Street Frontage Landscape Buffer Requirements (146-4.7.5.D)						
Street	Distance	Buffer Width	Trees Required (1 tree per 40LF)	Trees Provided	Shrubs Required (10 shrubs per 40LF)	Shrubs Provided
Tower Road	219LF	25'		6	6	55
E 22nd Place	225LF	6"		6		57
Andes Way	205LF	10'		5	5	52
*Buffer reduction used on E 22nd Place from 10' - 6' wide. Buffer reduction method used: Masonry Wall.

Project Name	SEMI TRUCK PARKING
Project Address	2252 TOWER ROAD AURORA, CO 80011
Scale	SCALE - 1:50
Description	LANDSCAPE PLAN

L 1.0

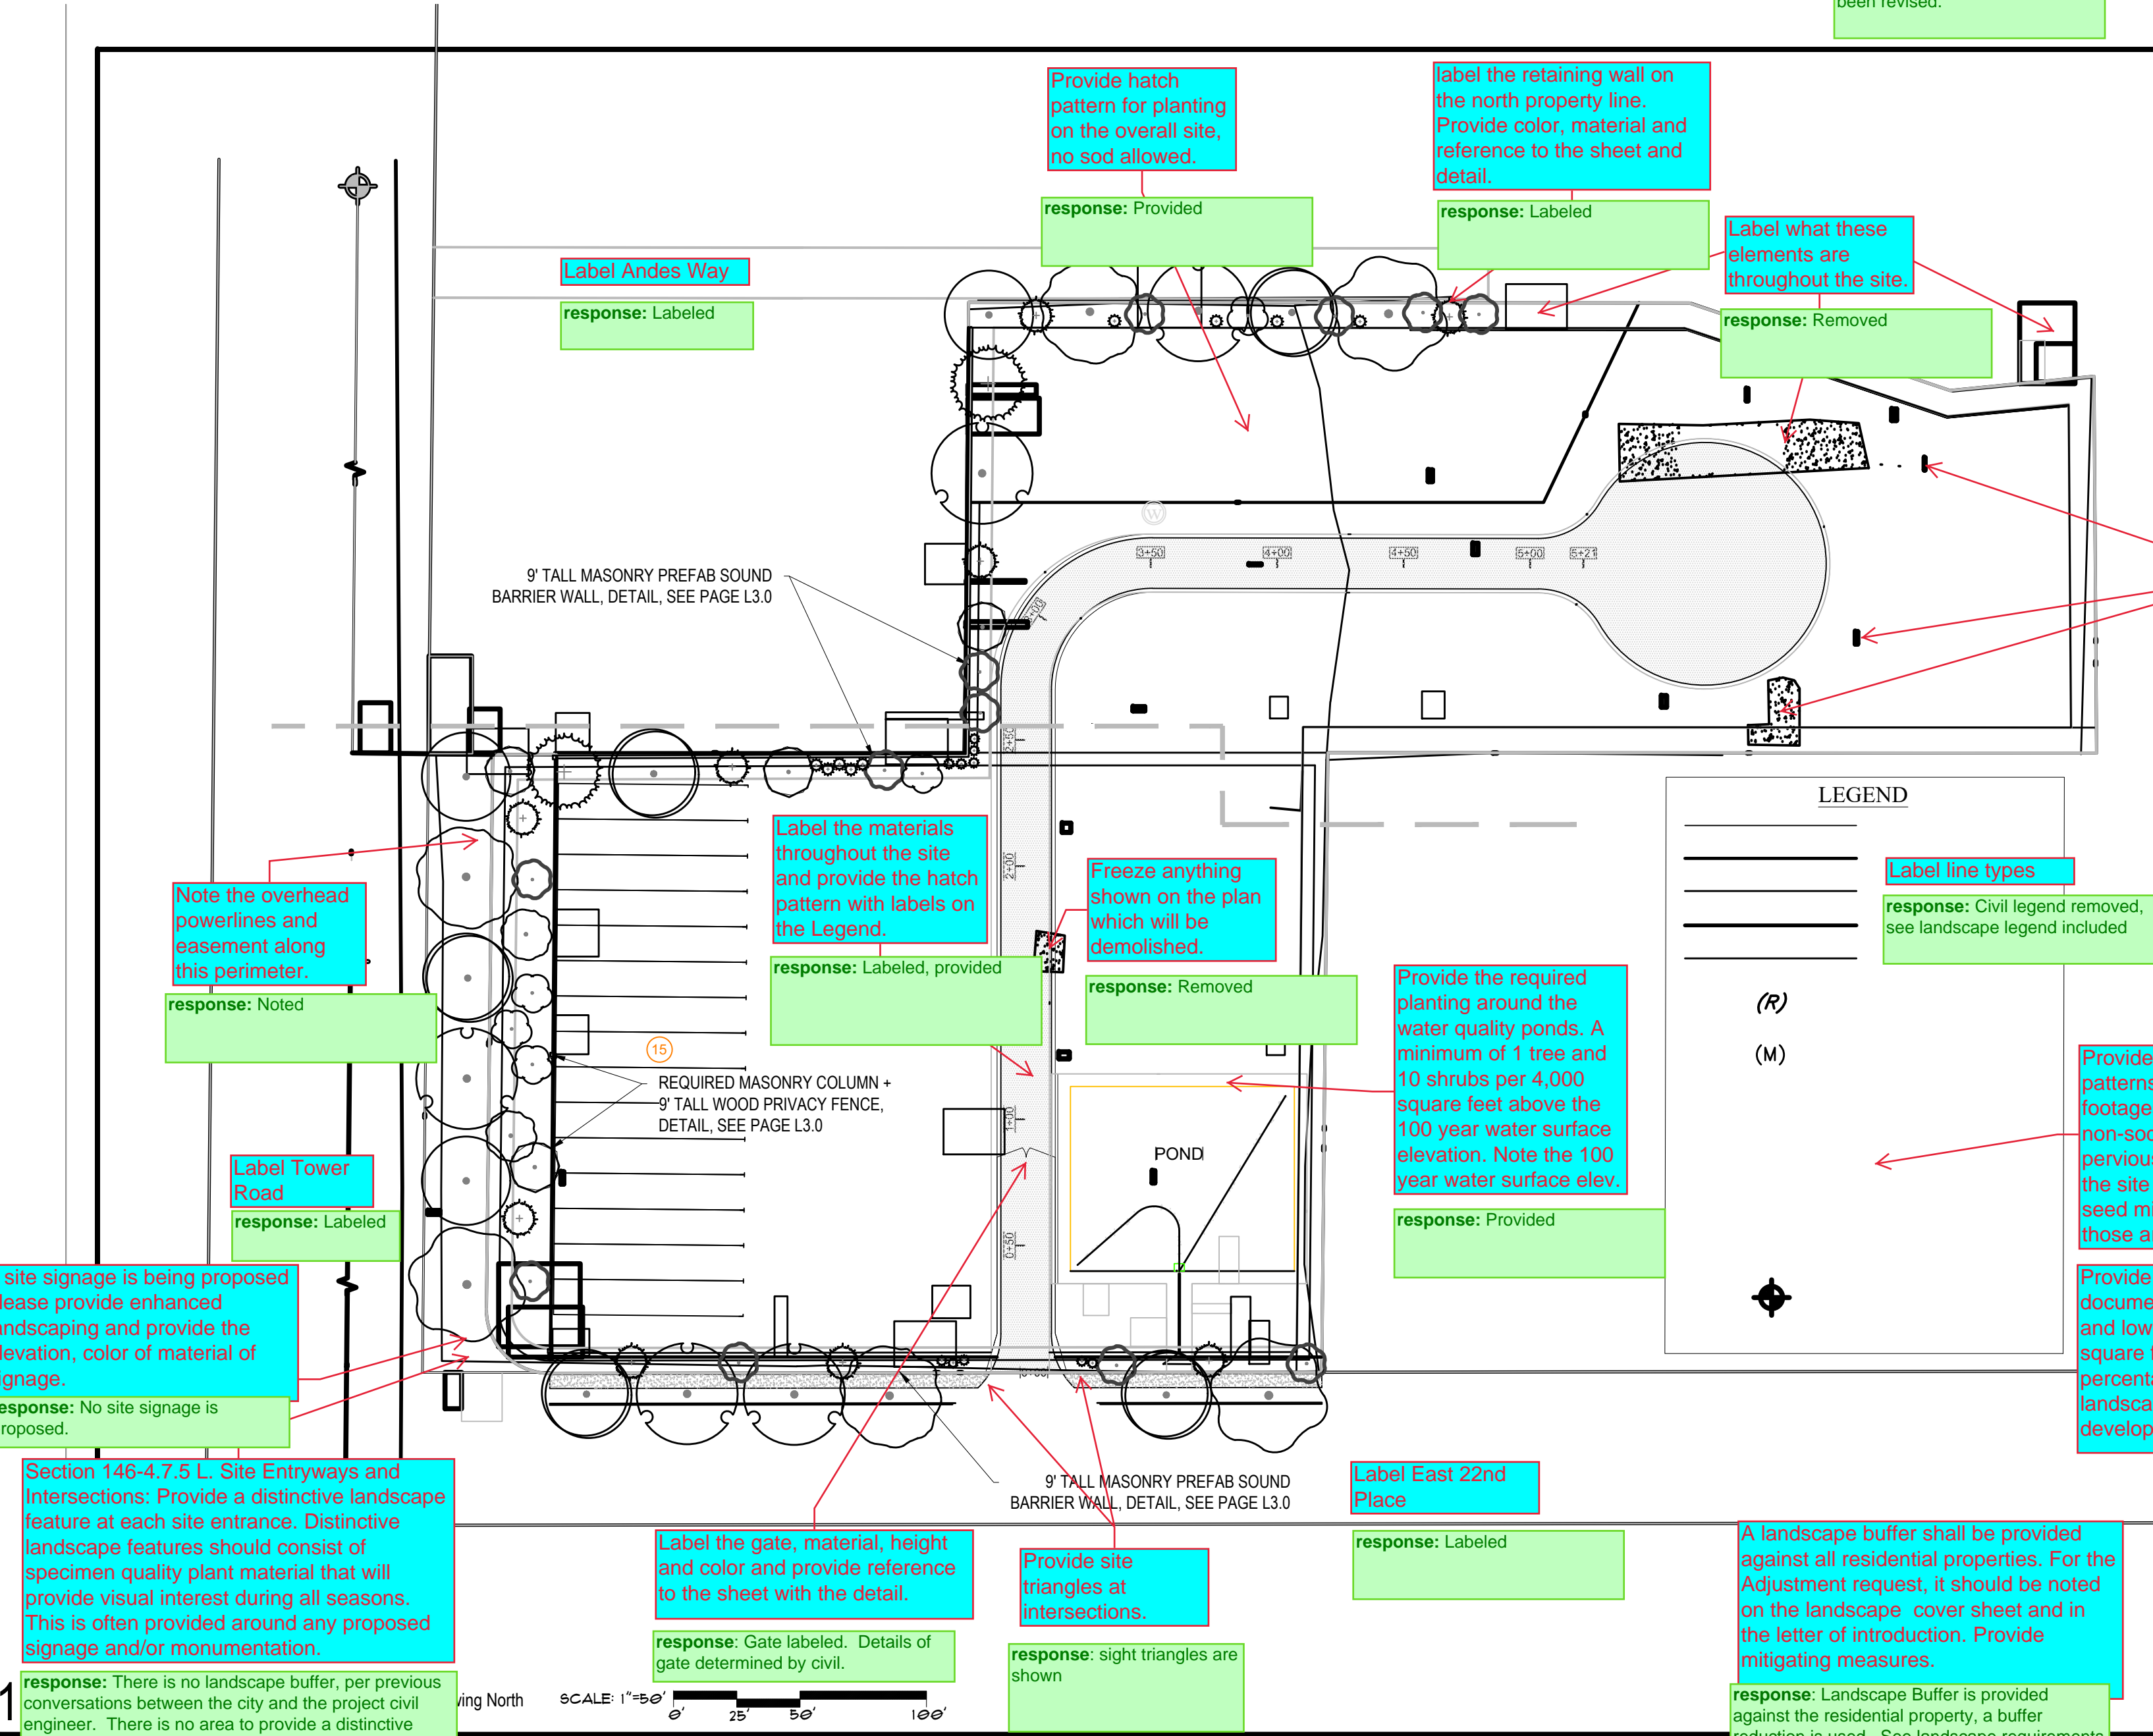
- IRRIGATION REQUIREMENTS:**
- POP UP SPRAYS TO TURF, DOUBLE COVERAGE THROUGHOUT.
 - D RIP IRRIGATION TO ALL TREES, SHRUBS AND PERENNIALS MAY VARY, DEPENDING ON LOCATION.
 - PLACE EMITTERS ON UPHILL SIDE OF PLANT IN SLOPED LOCATION.
 - IN THE CASE OF MULTIPLE EMITTERS AND FLAT SITE, PLACE EMITTERS EQUIDISTANT AROUND ROOTBALL.
- response:** Sheet numbers updated
- Make sure that the sheet numbering is consistent throughout the plan set. The LA sheet numbers should be shown on the overall project cover sheet. The numbering should be cumulative. Sheet X of X.

Section 146-4.7.5.E.2.b. Non-Street Perimeter Buffers
A 25' wide non-street perimeter landscape buffer is required adjacent to the existing residential property. A buffer reduction to 12' is permitted depending upon the buffer reduction feature chosen as specified in Table 4.7-2 Required Landscaping Buffer Widths and Allowed Reductions. While the buffer widths are less restrictive, plant quantities remain consistent. Plant material shall be provided at a ratio of one tree and five shrubs per 25 linear feet and 50% of the tree species shall be evergreen. Plant sizes shall be increased to three-inch caliper for deciduous shade trees and eight feet tall for evergreen trees between non-residential and residential uses. While additional non-street buffers are required adjacent to the adjoining industrial properties, given the nature of the uses, staff would be in support of an adjustment request to not provide the required buffer. Adjustment requests should be accompanied by mitigating measures to offset the adjustment request. In addition, the adjustment should be listed on the Cover Sheet and Landscape Plan sheet with the plan set and the Letter of Introduction should be updated to reflect the adjustment request and the mitigating measures being taken to offset the adjustment.

Plant material shall be chosen based upon its ability to provide appropriate screening and shall be selected to reach a mature height of no less than five feet. Perennials shall only be used as accents and may not count toward the buffer requirement. Shrubs and ornamental grasses may not be substituted for the tree requirement unless the site is encumbered. Refer to the UDO for what is considered an encumbrance. While Junipers are commonly used for buffer screening, alternative plant material shall be integrated that are better suited to winter snow loads and provide year-round visual interest. Refer to the UDO for an alternative plant list.

- A. EXISTING TO REMAIN UNLESS NOTED OTHERWISE
B.
- response:** Landscape Buffer is provided against the residential property, a buffer reduction is used. Appropriate mix of deciduous and evergreens are used. See landscape requirements table on sheet L1.0 and on cover sheet.
- Thank you for the adjustment support for the non-street buffer adjacent to industrial properties. See adjustment table on sheet L1.0 and on cover sheet.

1 OVERALL PLAN

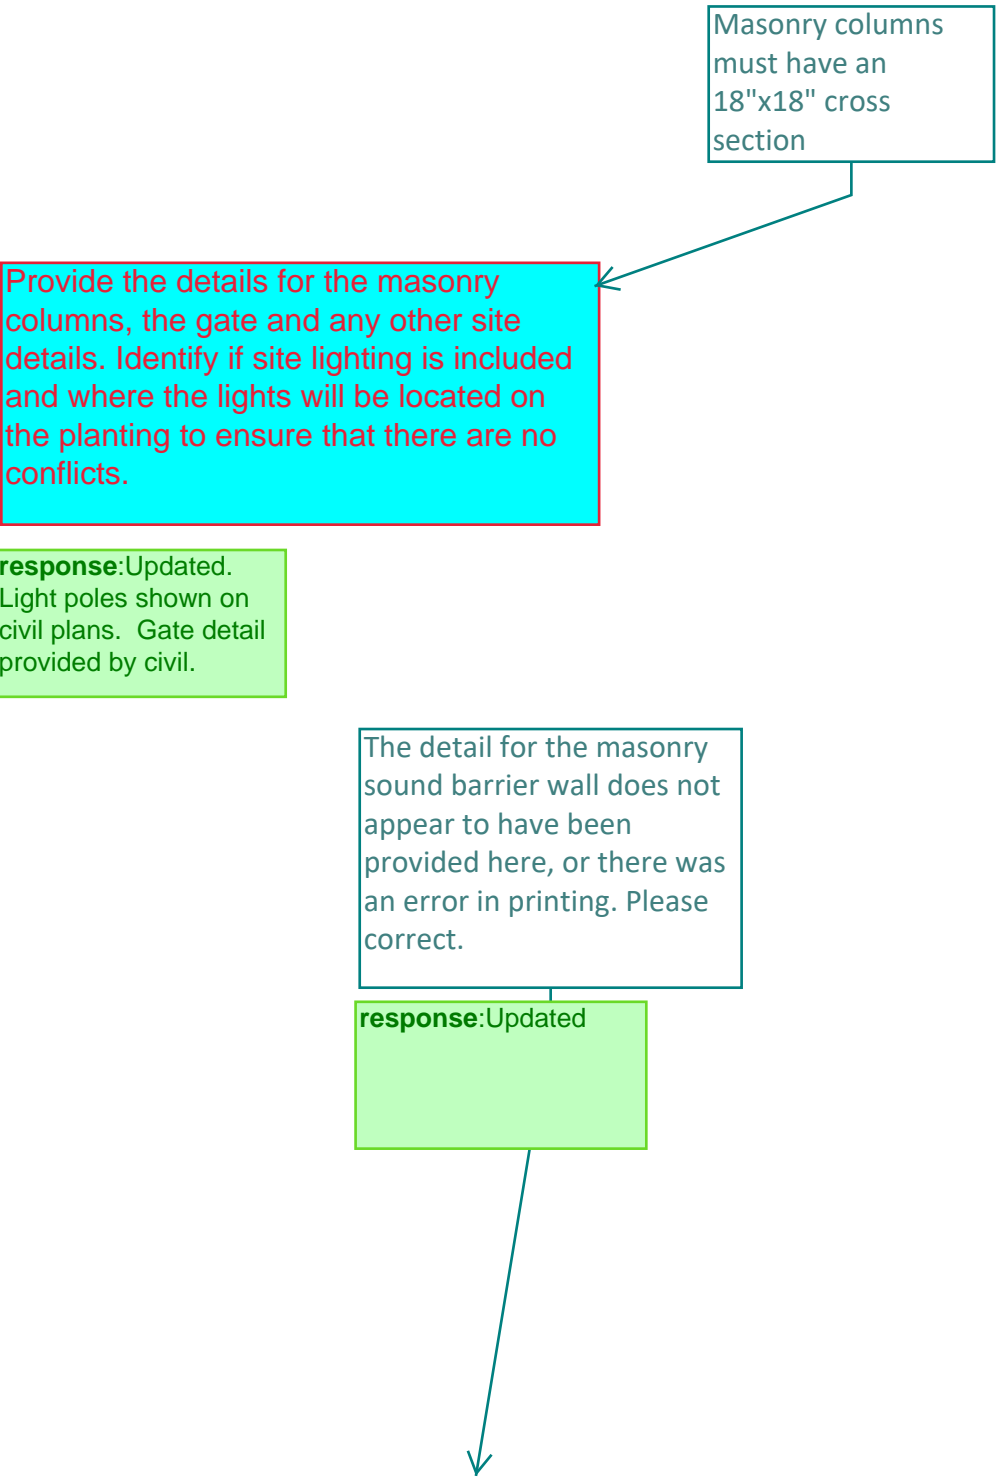
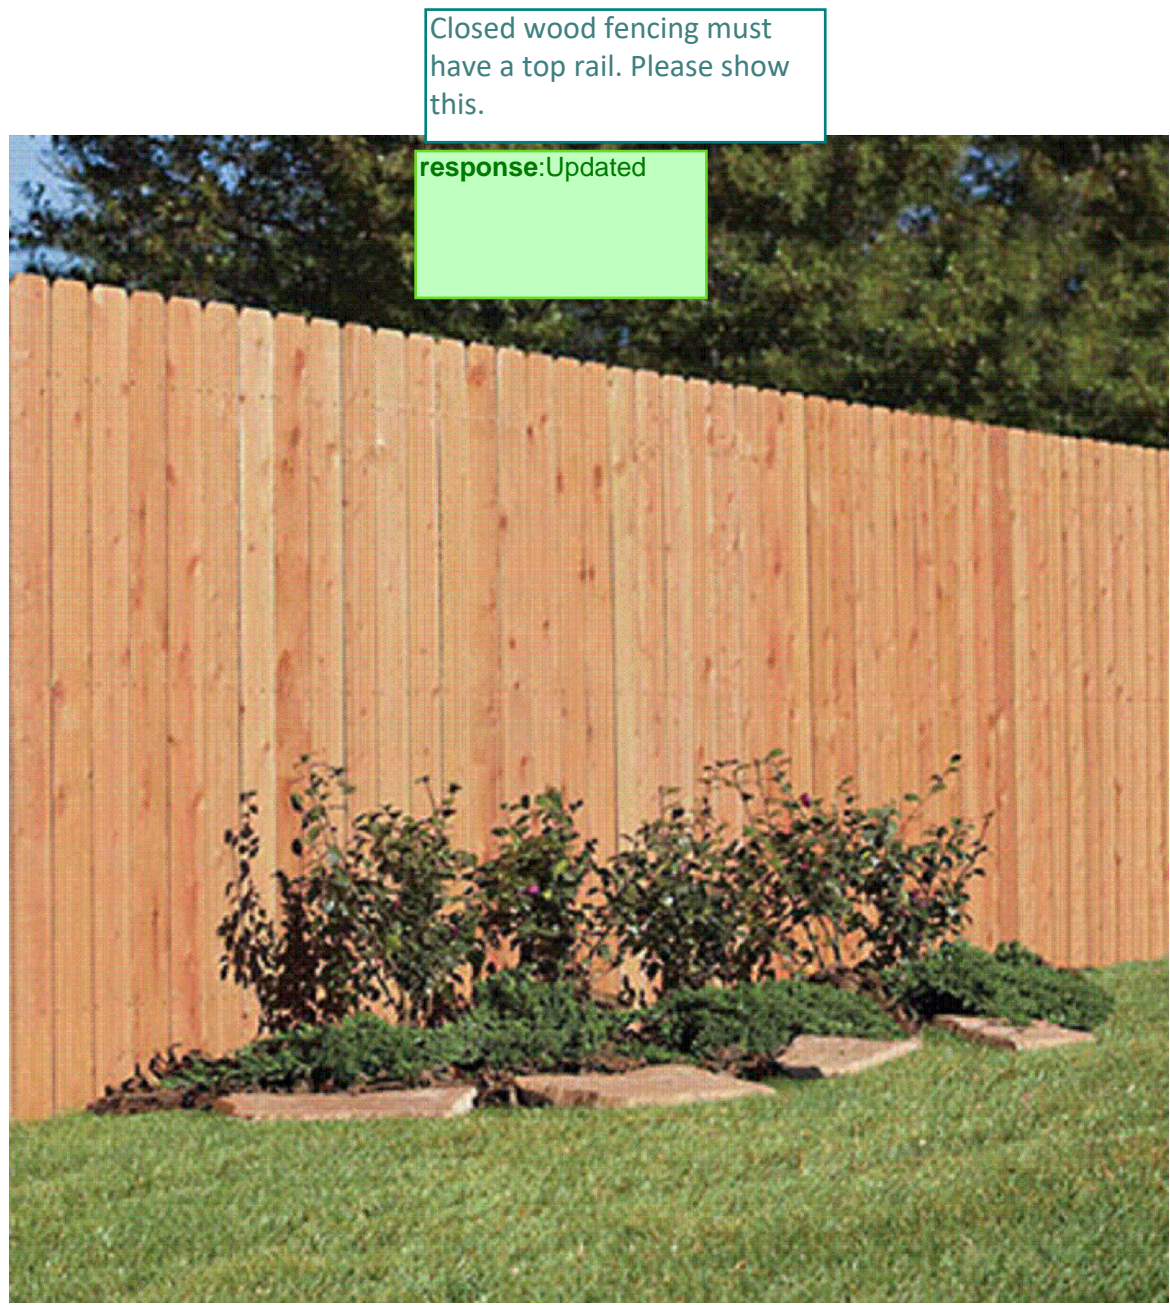
Note: NOT FOR CONSTRUCTION on the landscape plans.

response:noted
